SKF Technical Bulletin

VKJC 1045/1046/5205/5208 – Mandatory Stub-shaft kit replacement combined with driveshaft kit

VW Multivan V, Transporter V

Pic. 1

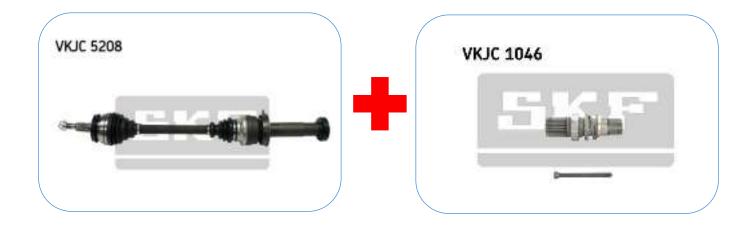
Due to vehicle transmission dysfunctions on the above applications, there are issues with the original gearbox side toothing the driveshaft which leads to premature stub-shaft and driveshaft failure, as shown below on Pic 1 and Pic. 2.

The problem will persist if the driveshaft is replaced without a new stub shaft. Indeed, the toothing of the original stub shaft will present more tolerance than required, so it will prematurely damage the driveshaft toothing.

Therefore, for a complete and professional repair, SKF is offering both components as this is mandatory to replace the driveshaft and the stub-shaft at the same time.
